REVISED RESPONSE TO REQUEST FOR ADDITIONAL INFORMATION

APR1400 Design Certification

Docket No. 52-046

RAI No.: 13-7856
SRP Section: 12.02 – Radiation Sources
Application Section: 12.2
Date of RAI Issued: 05/22/2015

Figure 1. Shielding and Layout of Holdup Tank

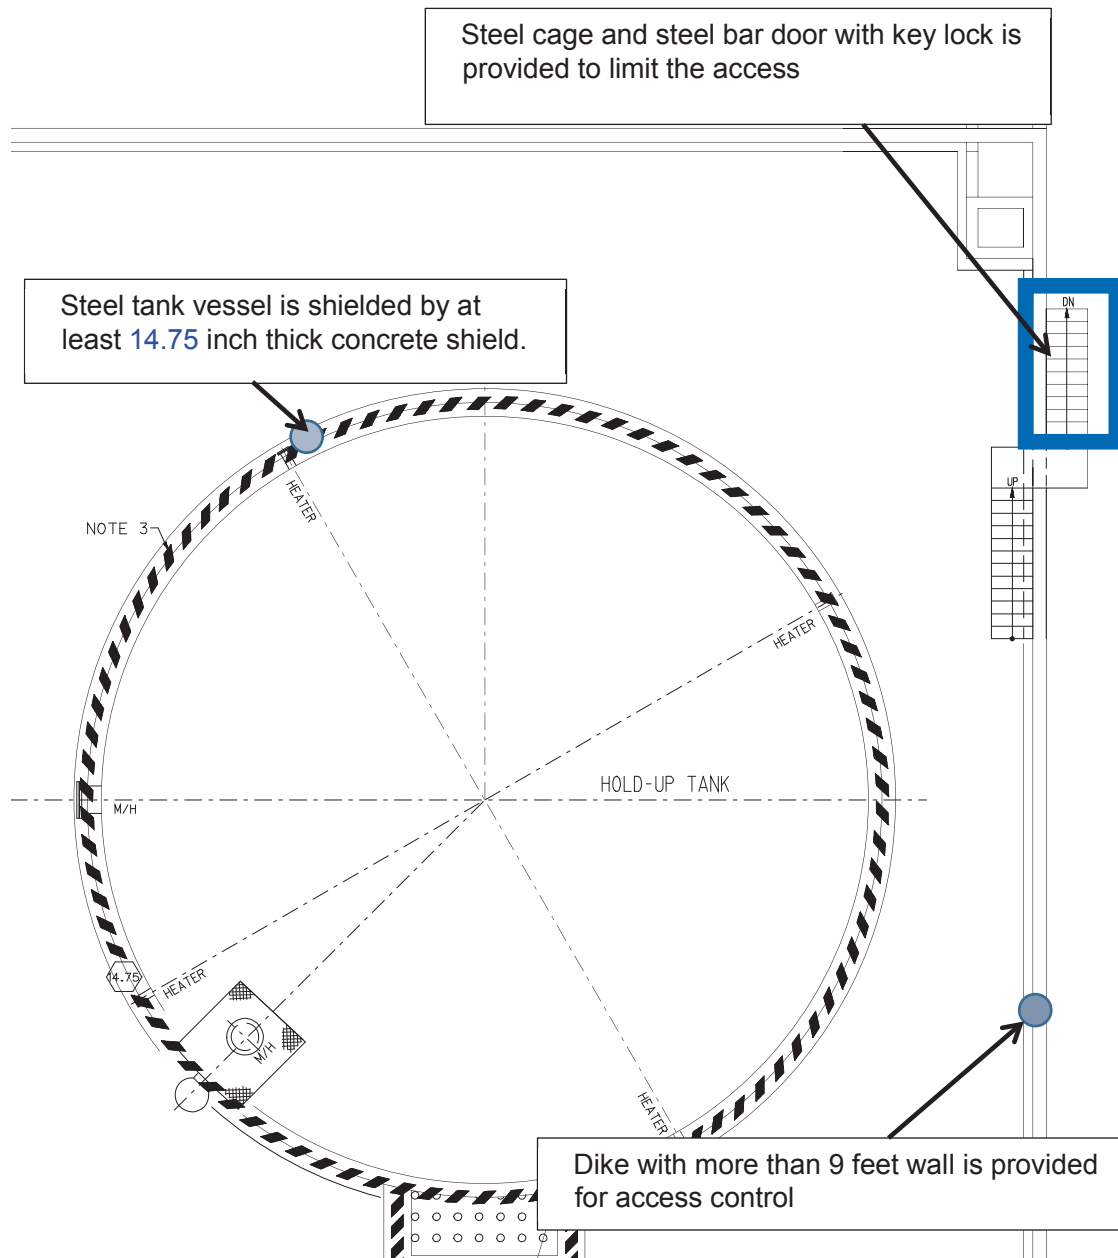
5. While the source term for the holdup tank is fairly significant, it appears to be significantly lower than the source term provided for a tank which appears to have a very similar function in another new reactor design. Please discuss all potential input paths of radioactive material to the holdup tank. If potential input paths that would result in a significantly higher source term than what is provided in FSAR Table 12.2-13 exist, please discuss why the current source term is adequate. Please provide the methods, models, and assumptions used in calculating the source term for the holdup tank in FSAR Table 12.2-13 in the response.

- b. As presented in Figure 1, the holdup tank itself is composed of a steel vessel with a minimum 14.75-inch thick concrete shield wall outside the vessel to ensure that the dose rate outside the tank is less than 2.5 $\mu\text{Sv/hr}$. This design feature is also applicable to the BAST. The RWMT is not shielded with concrete since the design basis dose rate outside the vessel is low enough to maintain the dose rate below 2.5 $\mu\text{Sv/hr}$ without the concrete shield wall.

4. The Holdup Tank and the BAST are stainless steel tanks with a layer of concrete shield wall surrounding the tank, from bottom to top, with no gap between the tank surface and concrete wall. The thickness of the concrete layer is provided in Table 1 below for convenience. These and other parameters are added to Table 12.2-25 (Please refer to response to Issue #2 above). Please also note that other design features of the tanks are discussed in response to Issue #3 above.
